FINAL DRAINAGE REPORT
for
EAGLE FOREST SUBDIVISION

JPS Project No. 010501
EPC Project No. SF-21-___

SF-21-31

DETENTION BASIN OUTLET STRUCTURE DESIGN

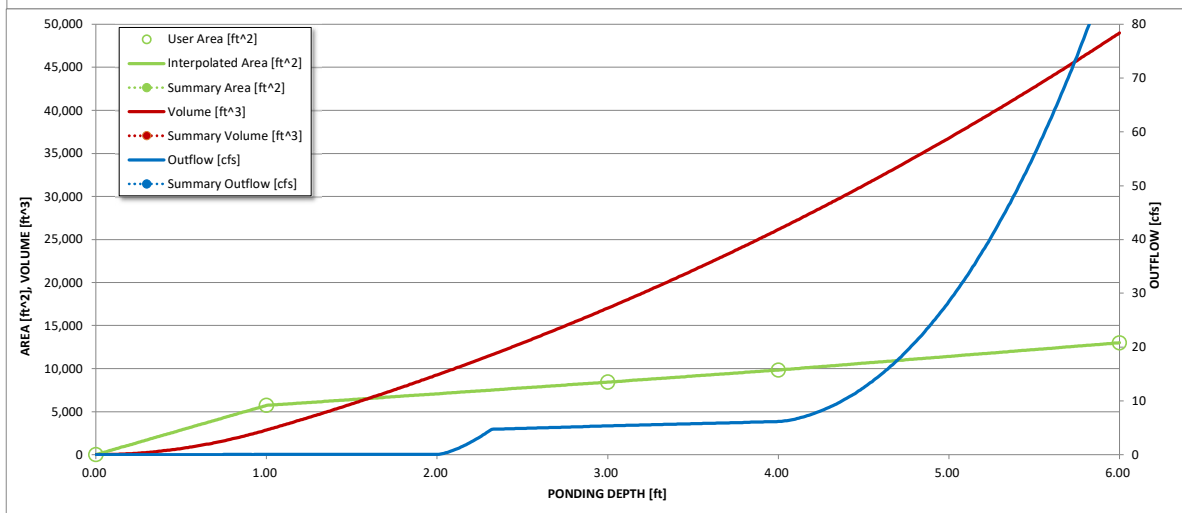
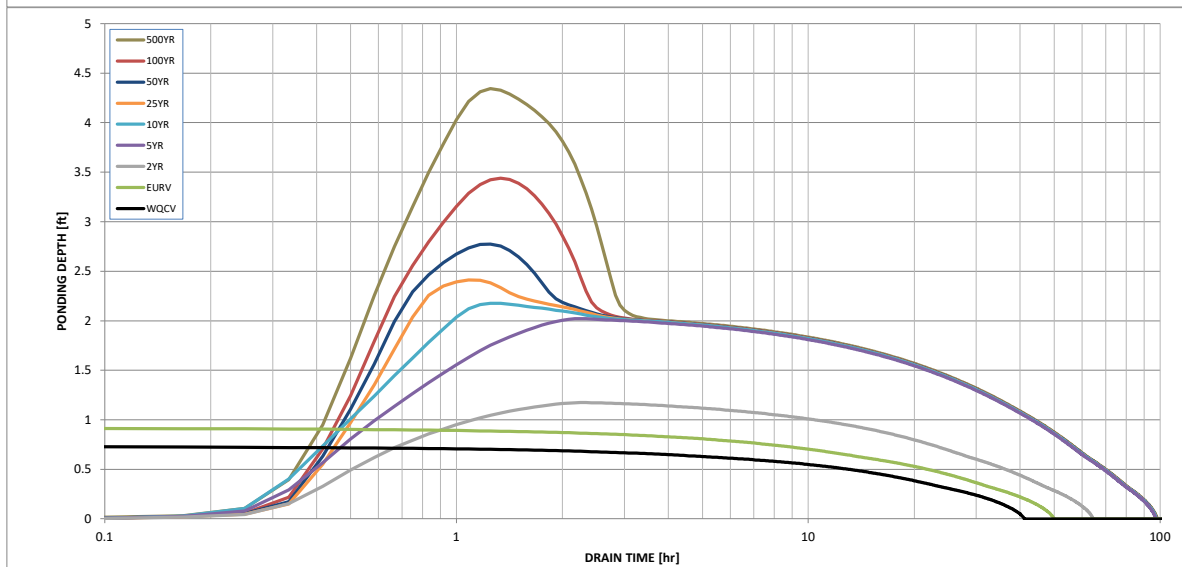
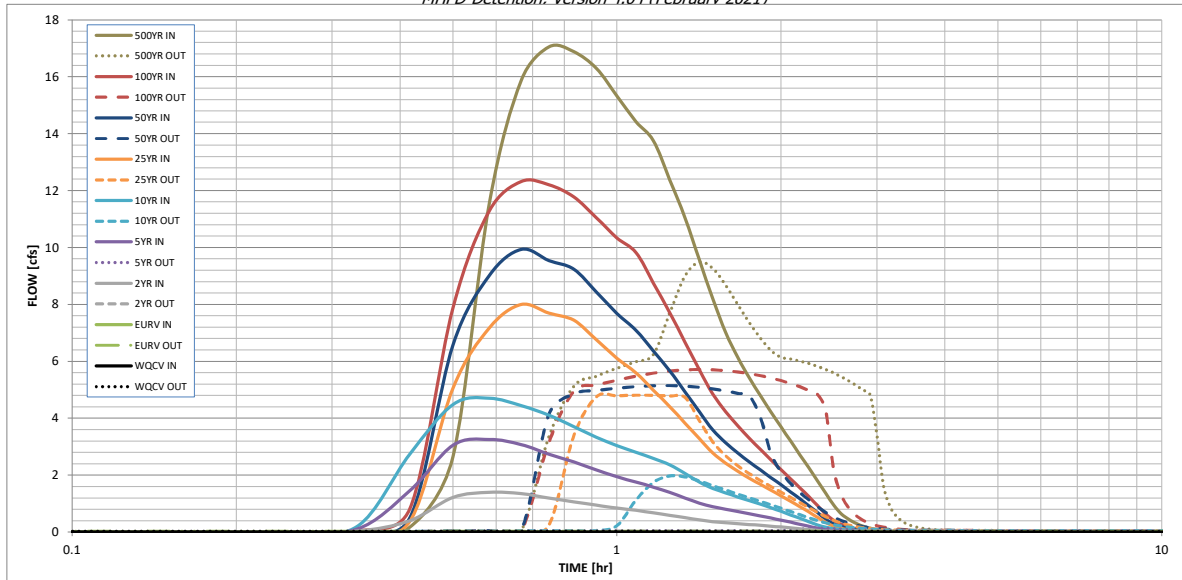
Please update plans to show design. Per construction drawings the spillway crest is 6' wide.

DEVELOPED DRAINAGE & EROSION CONTROL PLAN

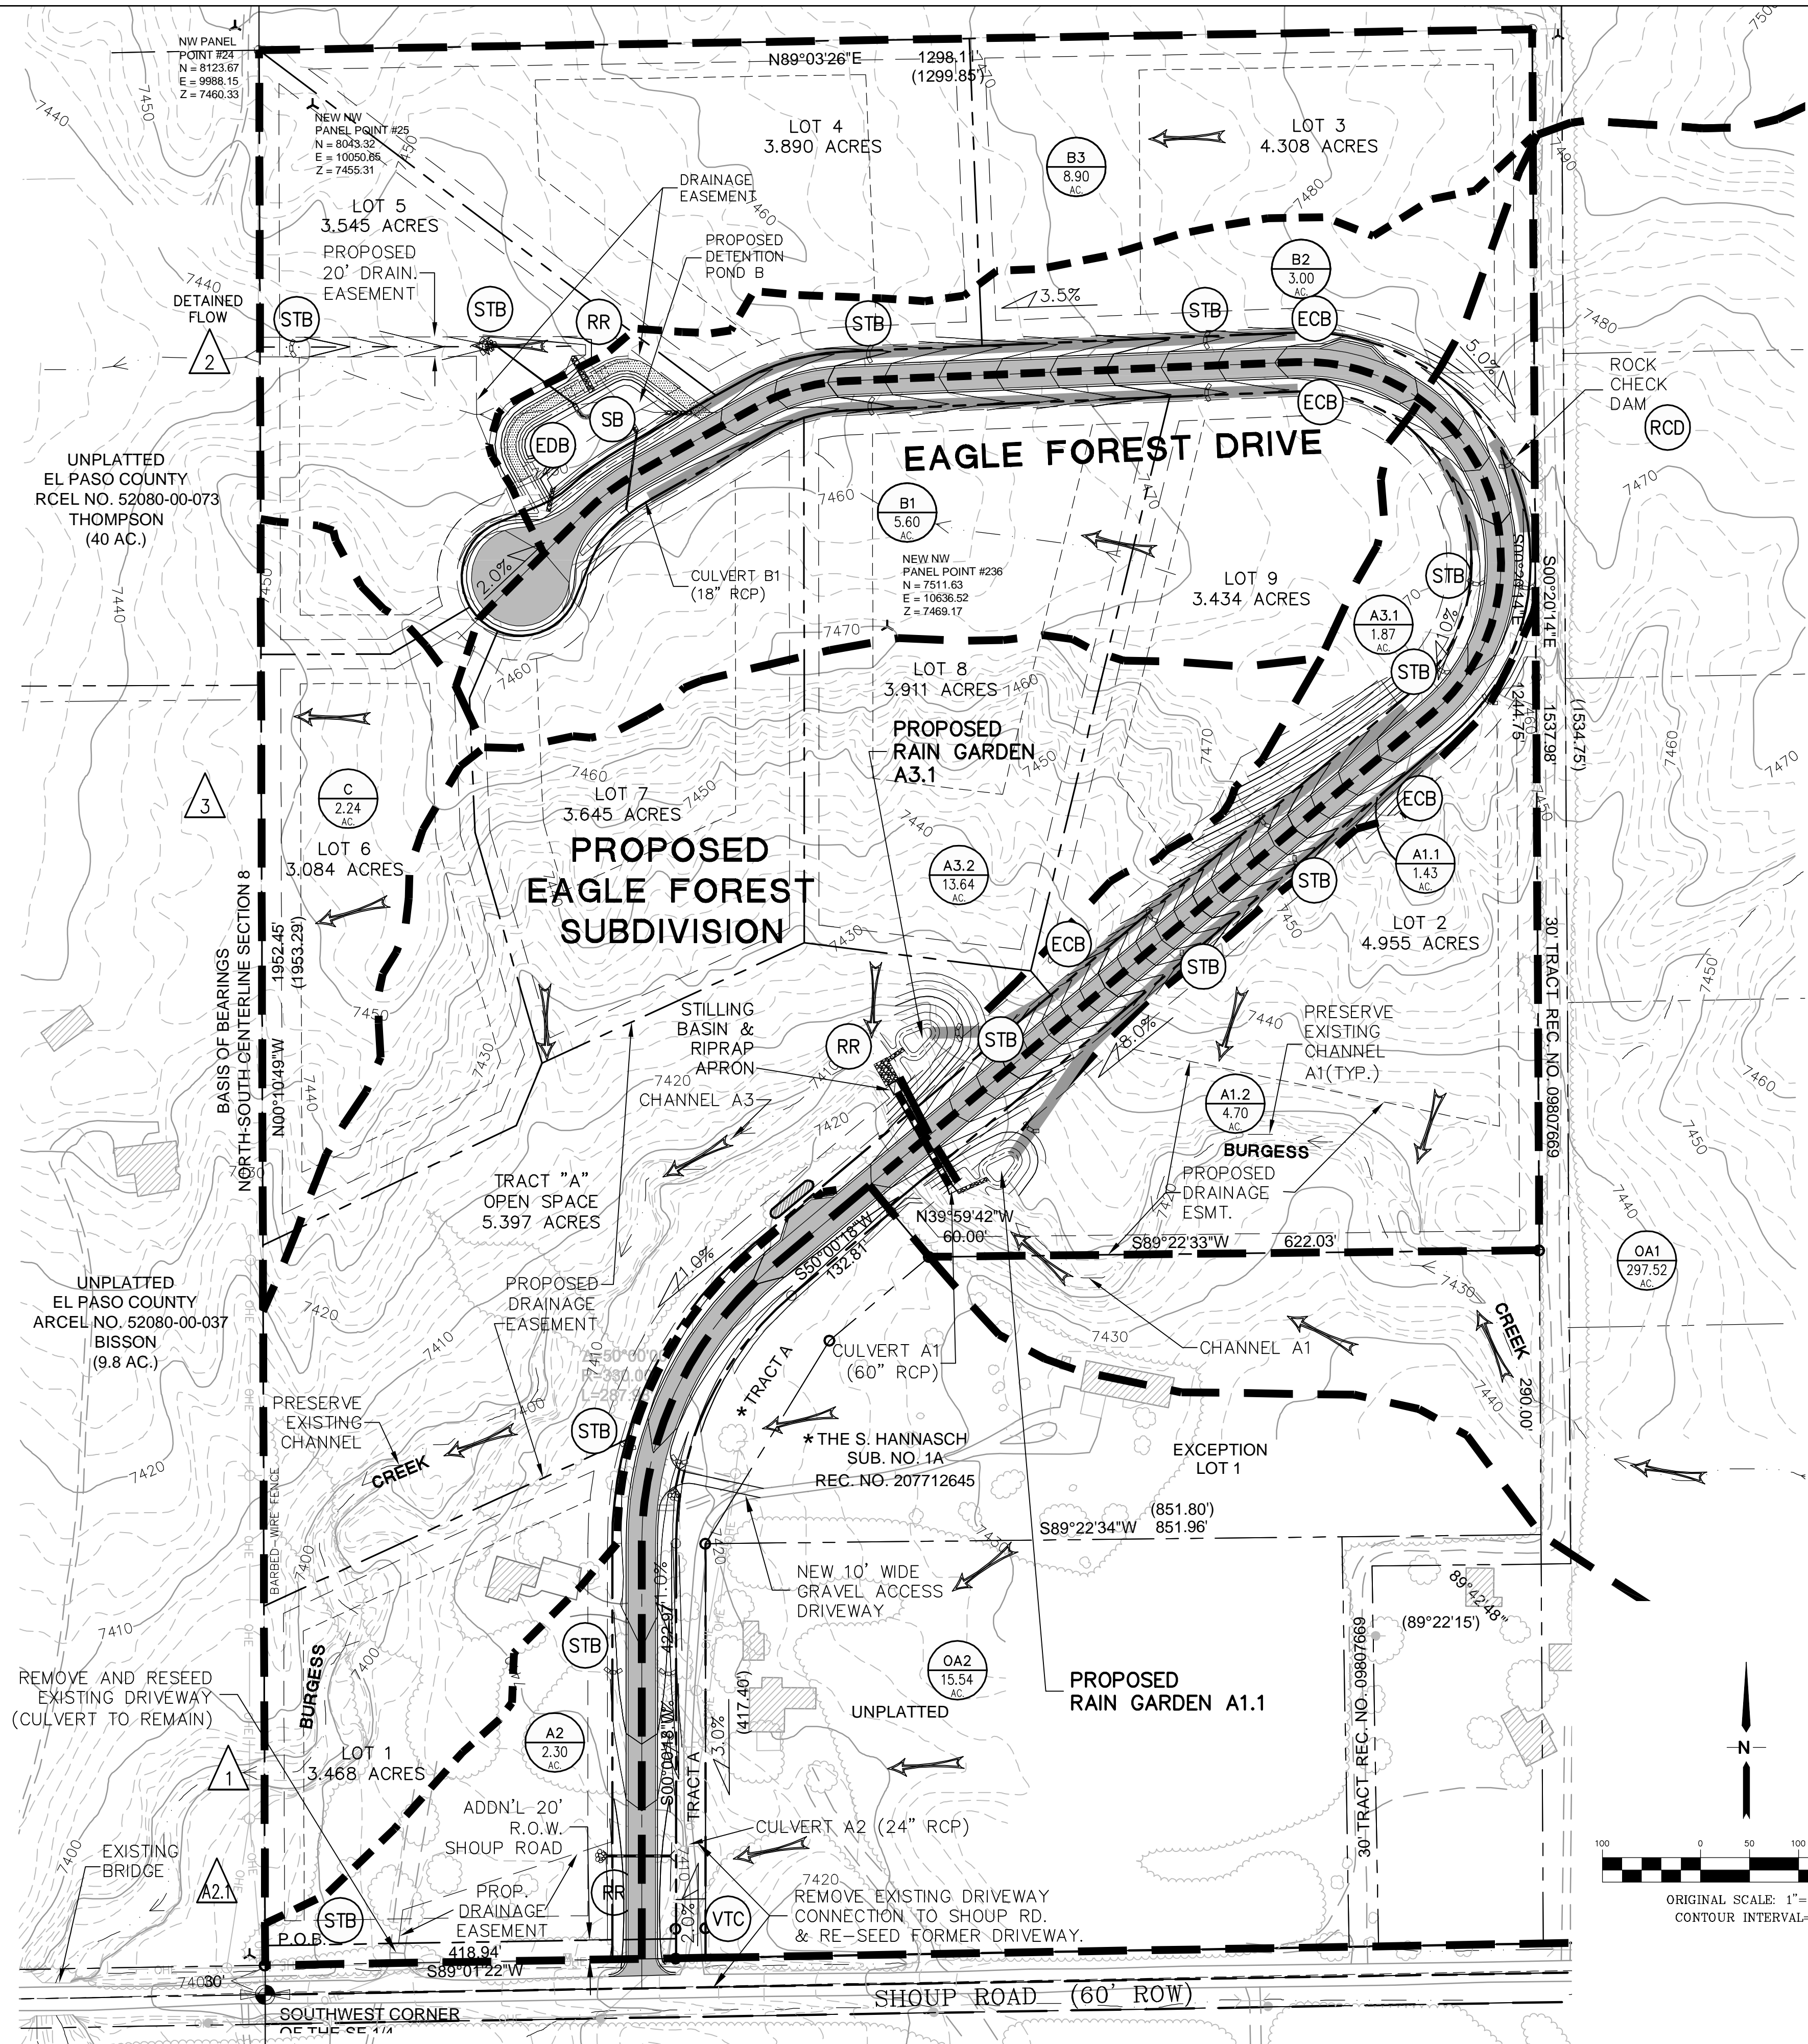
Please show time of concentration path on drainage map.
